ROCHESTER GAS AND ELECTRIC CORPORATION • 89 EAST AVENUE, ROCHESTER, N.Y. 14649

Subject: SEP Topic II-4.D, Stability of Slopes  
R. E. Ginna Nuclear Power Plant  
Docket No. 50-244

Attachment: Calculation of Internal Friction  
Angle, Cohesion and Travel Distance of a Mud Wave Generated  
From Slope Failure for SEP Topic II-4.D,  
Stability of Slopes, R. E. Ginna

Fig. 7-6a. Four diagrams illustrating the relationship between the critical height  $h_{cr}'$  of different slopes and the cohesion  $c$  of a clay weighing 100 lb/ft<sup>3</sup> ( $1.6$  gf/cm<sup>3</sup>). (Developed from Taylor, Ref. 330.)

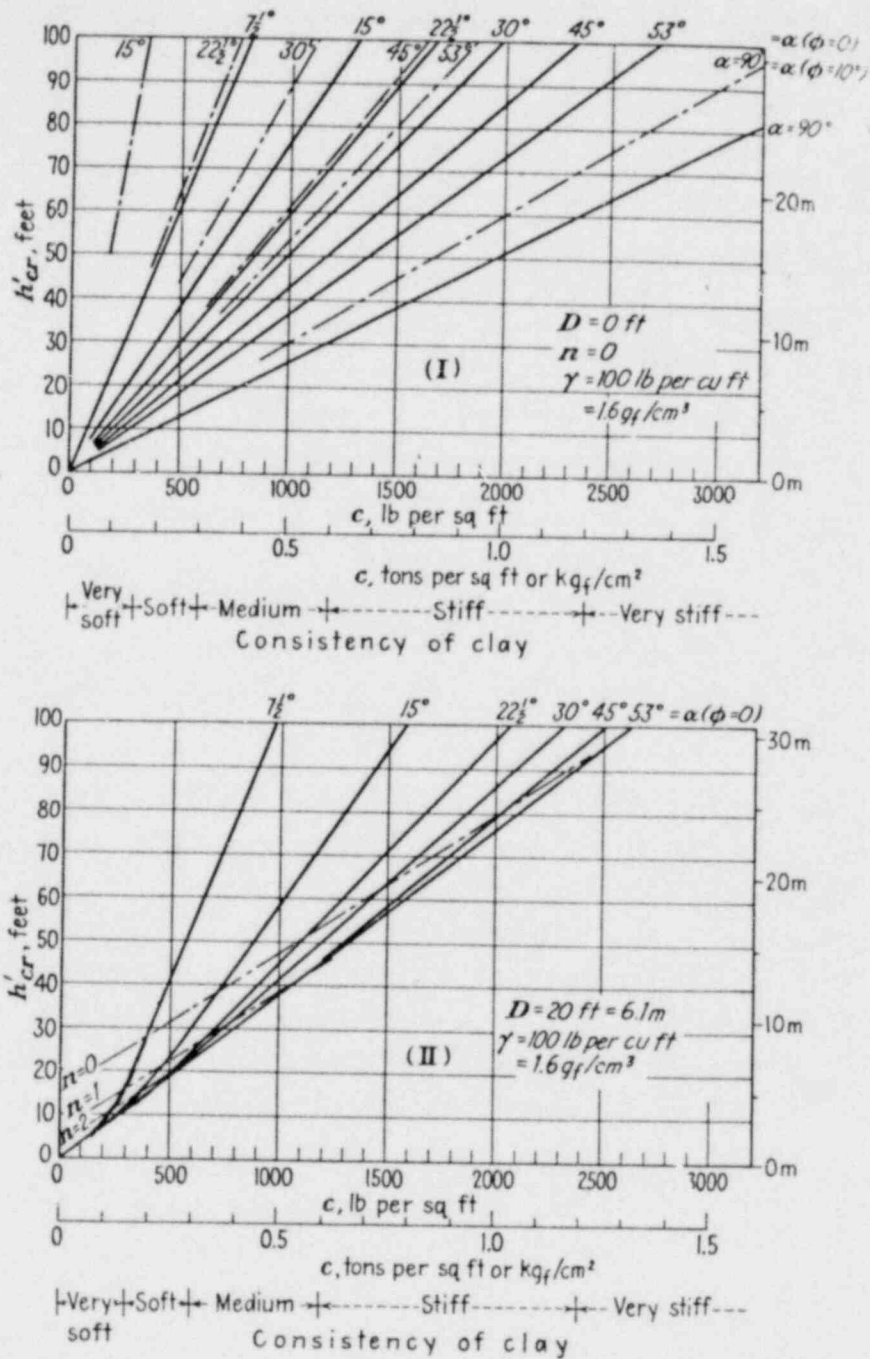
A relationship between the critical height  $h_{CR}$  of different slopes and the cohesion  $C$  of clay was developed by Gregory P. Tschebetarioff in Foundations, Retaining and Earth Structures © 1973, McGraw-Hill Inc. This relationship has been developed into charts from which one can estimate the length of travel of a possible mud slide which may occur in the case of slope failure. A copy of these charts is included as Figure 1. The full range of the possible developed cohesion  $C$  was evaluated to estimate the length of travel that each failure would incur for the corresponding calculated internal friction angles. The results of these calculations for both triaxial tests are included with this evaluation.

These calculations show that even in a worse case slope failure mode, the maximum distance traveled by the generated mud slide will be only 18.0 feet. Slope failure on the eastern slope will generate a mud wave that will propagate no closer than 95.0 feet from the east side of the greenhouse. Slope failure on the western slope will generate a mud wave that will propagate no closer than 210.0 from the northwest corner of the turbine building. Based upon this evaluation, we conclude that the onsite slopes at the R. E. Ginna plant present no threat to the safe operation of the facility.
